## Charlotte-Mecklenburg Planning Department

**SUBJECT:** Administrative Approval for Petition No. 2015-116 HWY 521 Partners, LLC

# COLINAYRE CHARLOTTE, NORTH CAROLINA

**REZONING SKETCH PLAN**

**RZ1.0**

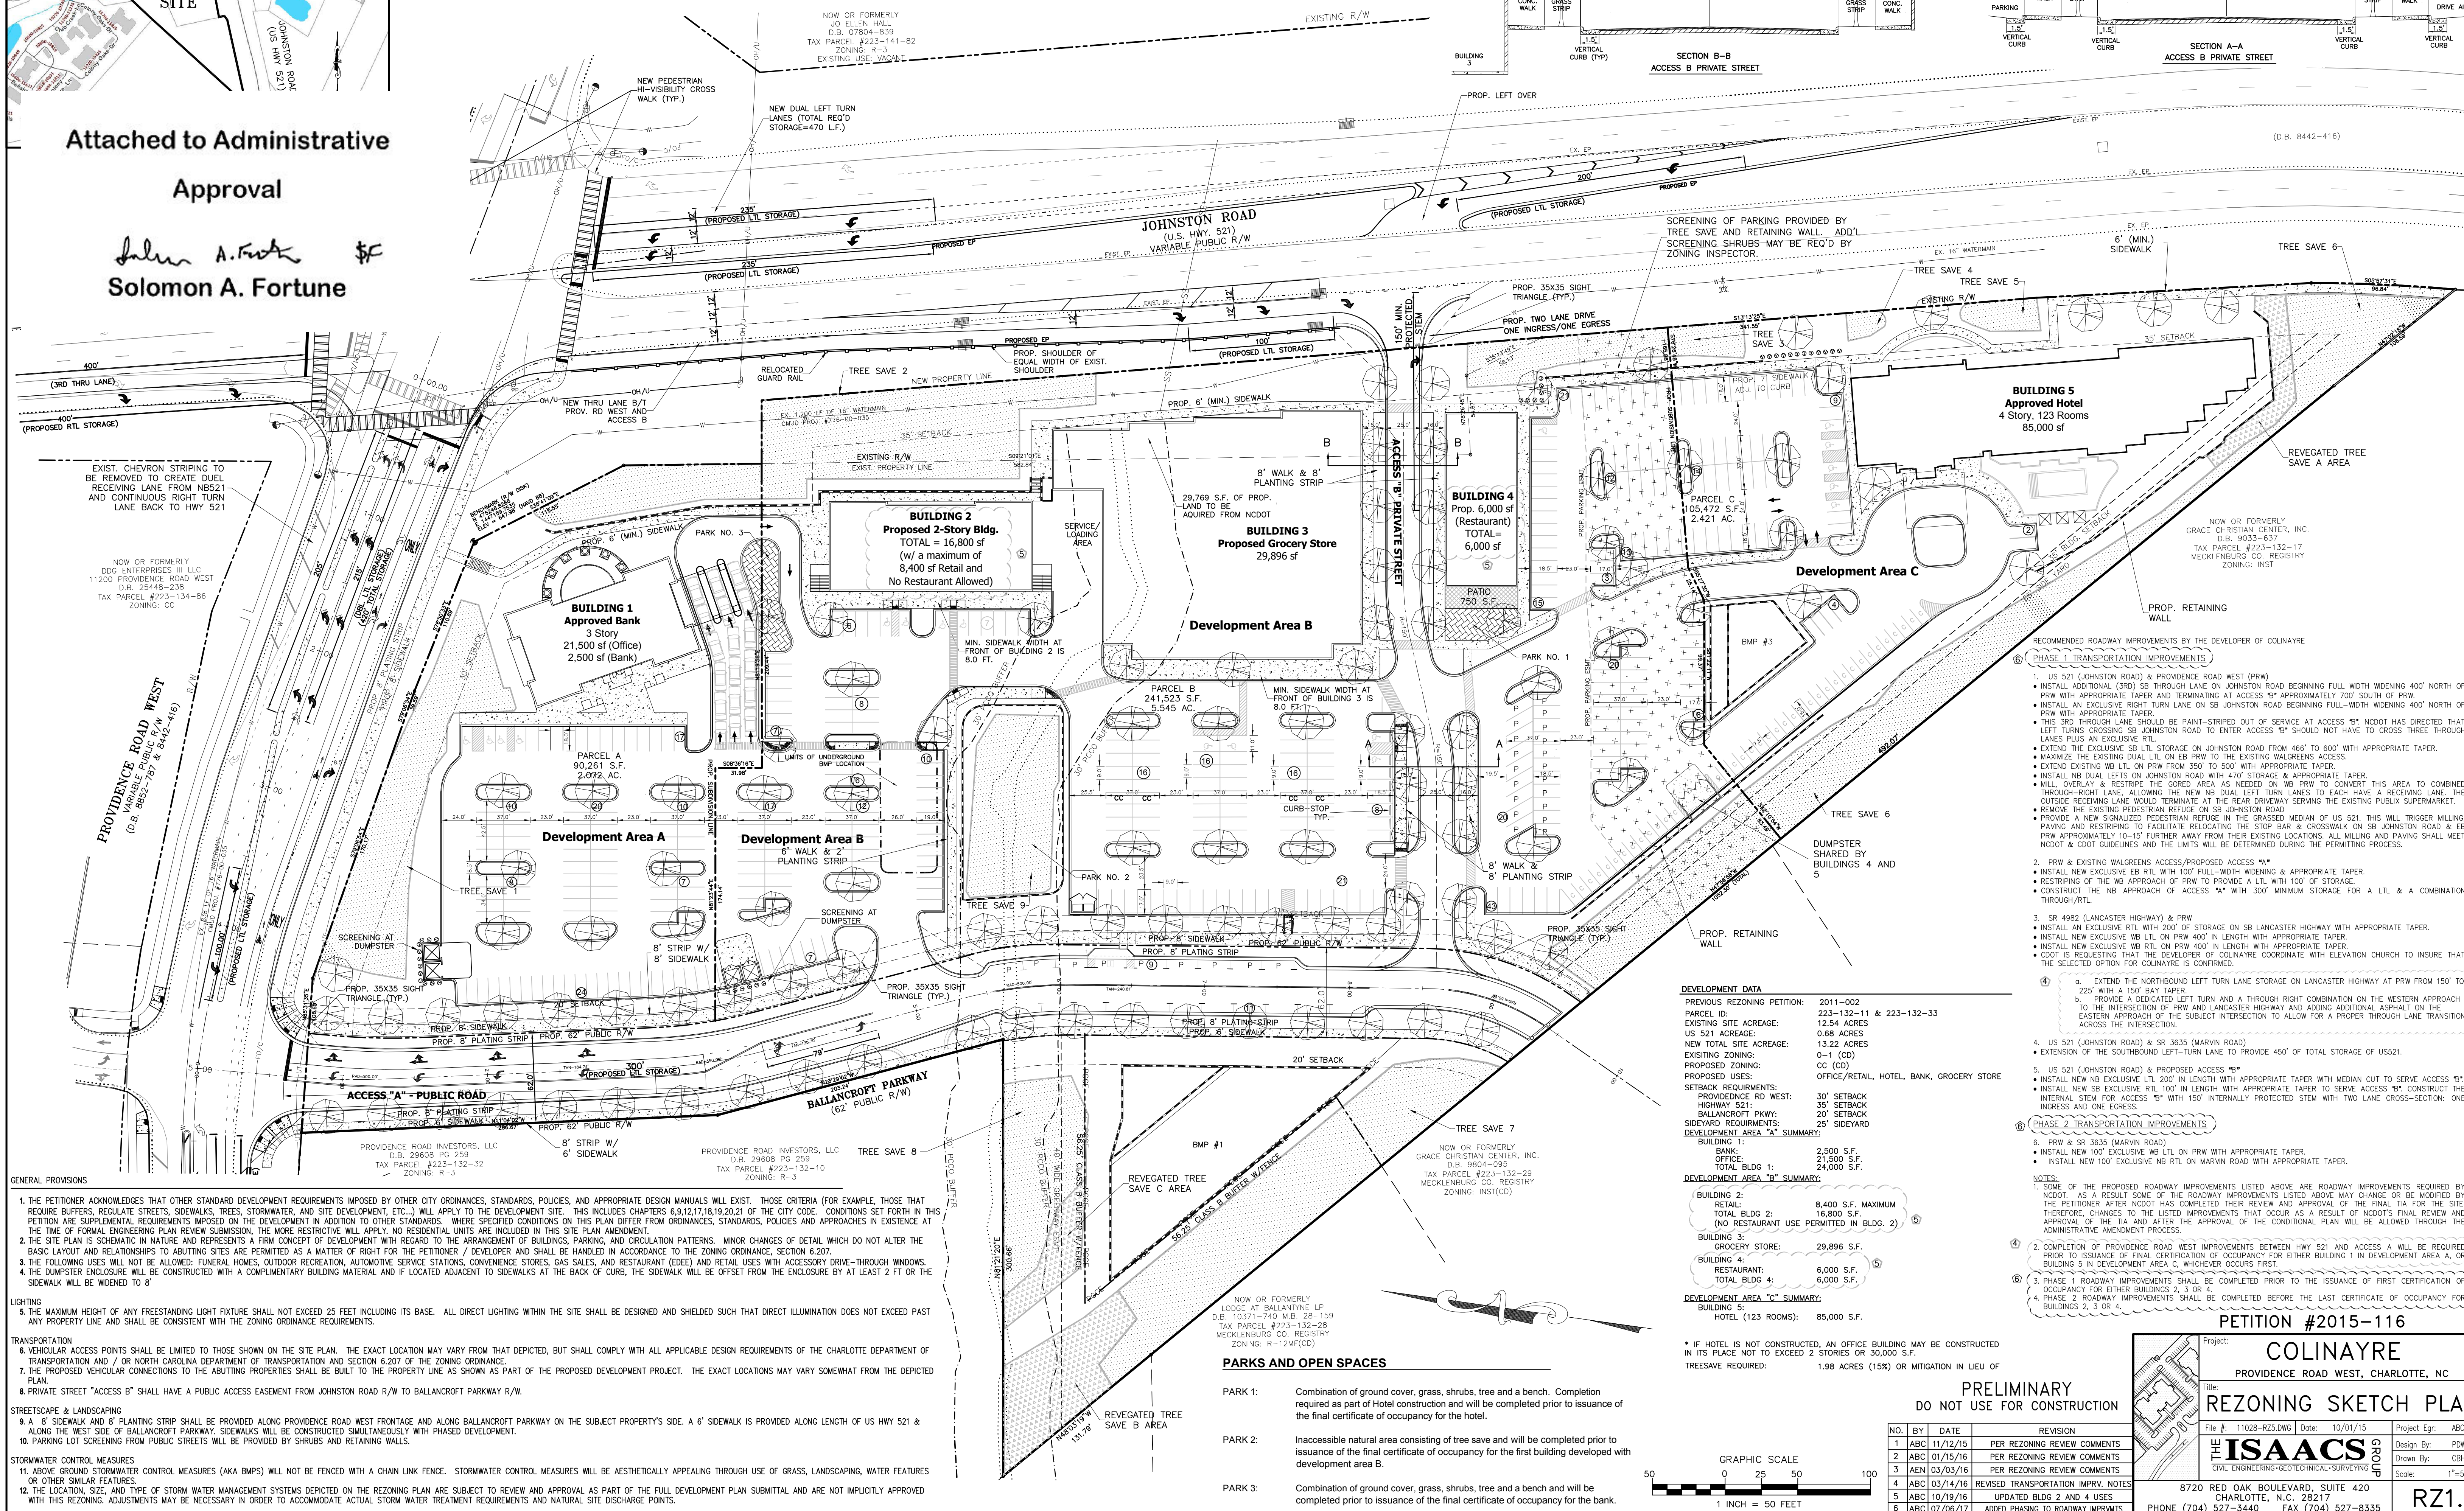
- Modification and phasing of transportation improvements.

- RECOMMENDED ROADWAY IMPROVEMENTS BY THE DEVELOPER OF COLINAYRE**
- PHASE 1 TRANSPORTATION IMPROVEMENTS**
- US 521 (JOHNSTON ROAD) & PROVIDENCE ROAD BEGINNING FULL WIDTH WIDENING 400' NORTH OF PRW WITH APPROPRIATE TAPER AND TERMINATING AT ACCESS "B" APPROXIMATELY 700' SOUTH OF PRW. INSTALL AN EXCLUSIVE RIGHT TURN LANE ON SB JOHNSTON ROAD BEGINNING FULL-WIDTH WIDENING 400' NORTH OF PRW WITH APPROPRIATE TAPER.

- THIS 3RD THROUGH LANE SHOULD BE PAINT-STRIPPED OUT OF SERVICE AT ACCESS "B". NCDOT HAS DIRECTED THAT LEFT TURNS CROSSING SB JOHNSTON ROAD TO ENTER ACCESS "B" SHOULD NOT HAVE TO CROSS THREE THROUGH LANES PLUS AN EXCLUSIVE RTL.

- EXTEND THE EXCLUSIVE SB LTL STORAGE ON JOHNSTON ROAD FROM 466' TO 600' WITH APPROPRIATE TAPER.
  - MAXIMIZE THE EXISTING DUAL LTL ON EB PRW TO THE EXISTING WALDRENS ACCESS.

- EXTEND EXISTING WB LTL ON PRW FROM 350' TO 500' WITH APPROPRIATE TAPER.
  - INSTALL NB DUAL LEFTS ON JOHNSTON ROAD WITH 470' STORAGE & APPROPRIATE TAPER.

- MIX OVERLAY & RESTRIPE THE CORDED AREA AS NEEDED ON WB PRW TO CONVERT THIS AREA TO COMBINED THROUGH-RIGHT LANE, ALLOWING THE NEW NB DUAL LEFT TURN LANES TO EACH HAVE A RECEIVING LANE. THE OUTSIDE RECEIVING LANE WOULD TERMINATE AT THE REAR DRIVEWAY SERVING THE EXISTING PUBLIC SUPERMARKET.

- REMOVE THE EXISTING PEDESTRIAN REFUGE ON SB JOHNSTON ROAD.
  - PROVIDE A NEW SIGNALIZED PEDESTRIAN REFUGE IN THE GRASSED MEDIAN OF US 521. THIS WILL TRIGGER MILLING, PAVING AND RESTRIPE TO FACILITATE RELOCATING THE STOP BAR & CROSSWALK ON SB JOHNSTON ROAD & EB PRW APPROXIMATELY 10-15' FURTHER AWAY FROM THEIR EXISTING LOCATIONS. ALL MILLING AND PAVING SHALL MEET NCDOT & CDOT GUIDELINES AND THE LIMITS WILL BE DETERMINED DURING THE PERMITTING PROCESS.

- PHASE 2 TRANSPORTATION IMPROVEMENTS**
- PRW & EXISTING WALDRENS ACCESS/PROPOSED ACCESS "A"
  - INSTALL NEW EXCLUSIVE EB RTL WITH 100' FULL-WIDTH WIDENING & APPROPRIATE TAPER.

- RESTRIPE OF THE NB APPROACH OF PRW TO PROVIDE A LTL WITH 100' OF STORAGE.
  - CONSTRUCT THE NB APPROACH OF ACCESS "A" WITH 300' MINIMUM STORAGE FOR A LTL & A COMBINATION THROUGH/RTL.

- SR 4982 (LANCASTER HIGHWAY) & PRW
  - INSTALL AN EXCLUSIVE RTL WITH 200' OF STORAGE ON SB LANCASTER HIGHWAY WITH APPROPRIATE TAPER.
  - INSTALL NEW EXCLUSIVE WB LTL ON PRW 400' IN LENGTH WITH APPROPRIATE TAPER.

- INSTALL NEW EXCLUSIVE NB RTL ON PRW 400' IN LENGTH WITH APPROPRIATE TAPER.
  - CDOT IS REQUESTING THAT THE DEVELOPER OF COLINAYRE COORDINATE WITH ELEVATION CHURCH TO INSURE THAT THE SELECTED OPTION FOR COLINAYRE IS CONFIRMED.

- PHASE 3 TRANSPORTATION IMPROVEMENTS**
- PRW & SR 3635 (MARVIN ROAD)
  - INSTALL NEW 100' EXCLUSIVE NB LTL ON PRW WITH APPROPRIATE TAPER.
  - INSTALL NEW 100' EXCLUSIVE NB RTL ON MARVIN ROAD WITH APPROPRIATE TAPER.
